**Proposed Temporary Warehouse with Ancillary Facilities for a Period of 3 Years
and Associated Filling of Land in “Residential (Group D)” and “Agriculture” Zones,
Various Lots in D.D. 38 and Adjoining Government Land, Sha Tau Kok, New Territories**

(S.16 Planning Application No. A/NE-MUP/214)

Response-to-Comment

Geotechnical Planning Review Report

Figure 8 – Preliminary NTHS Area and Section

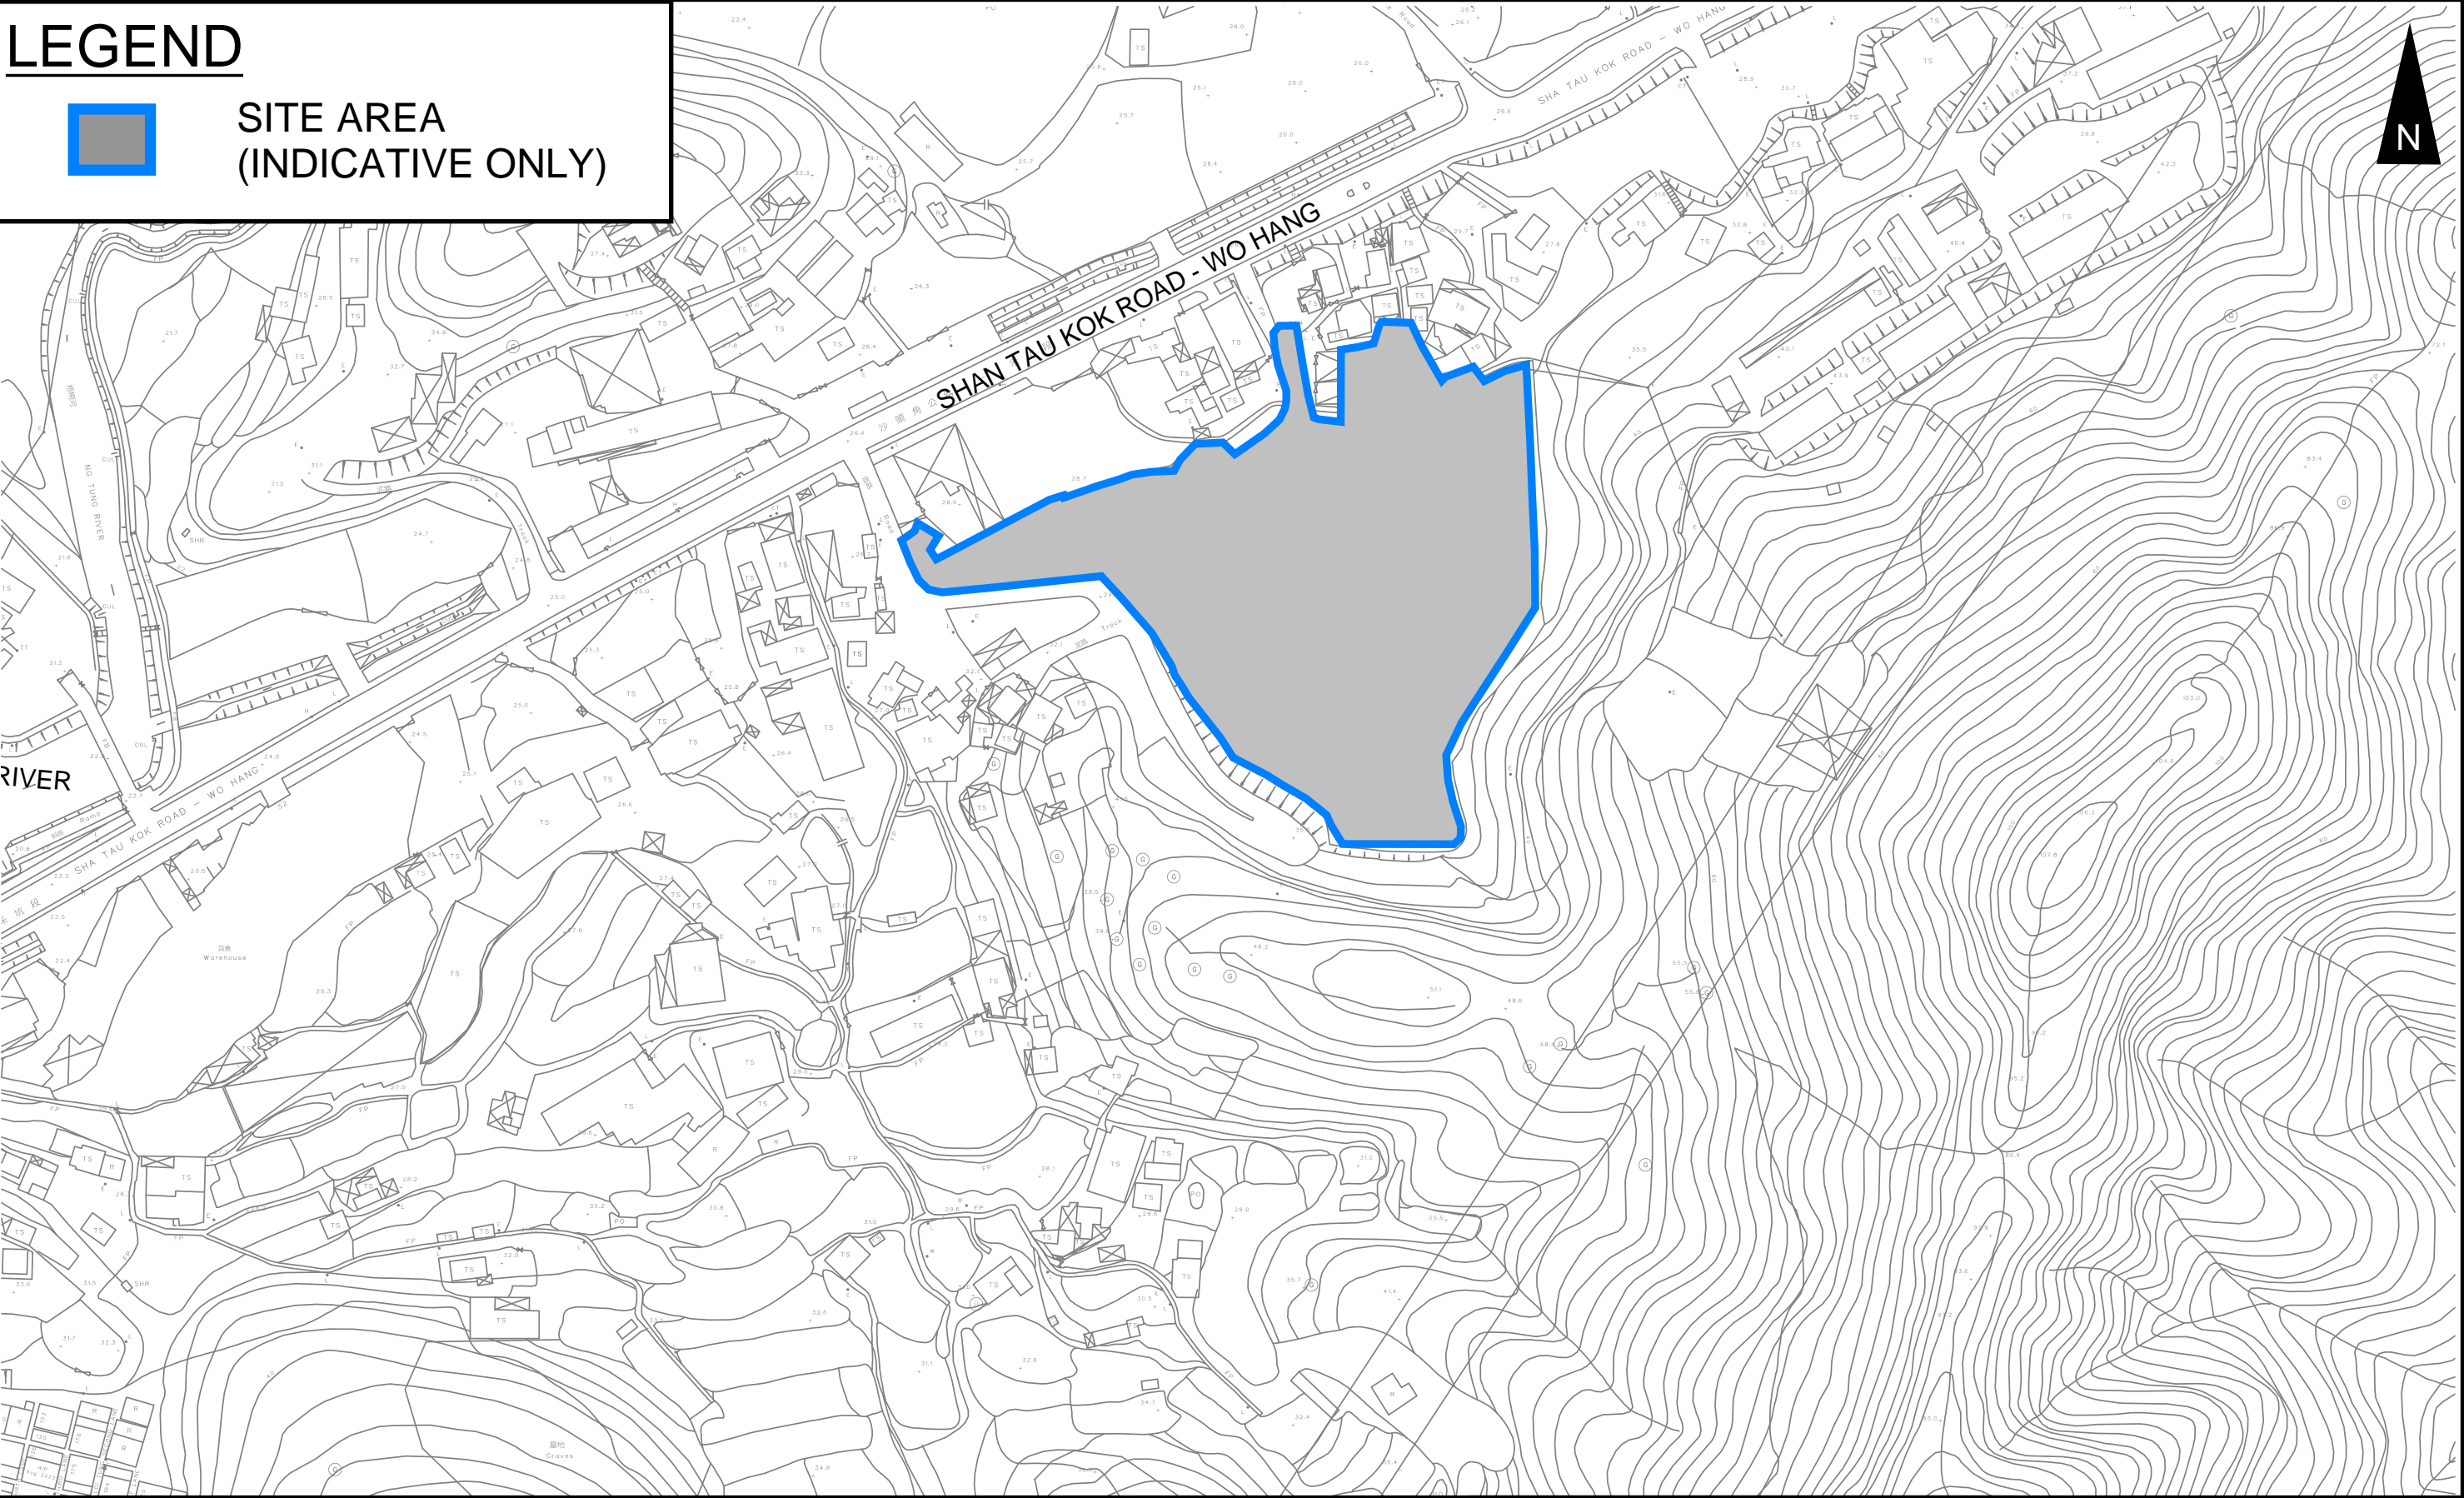
Angular Elevation $\geq 20^\circ$	Within 50m of ground sloping	Alert Criteria met?
Yes	Yes	Yes

- 6.1.2 The preliminary NTHS Area and section have been development and shown in **Figure 8**. A detailed natural terrain hazard study will be carried out in detailed design stage. Implementation of the mitigation measures if necessary (such as rigid barrier, flexible barrier etc.) will be conducted at construction stage. Therefore, the application site is considered geotechnically feasible from the NTH point of view.
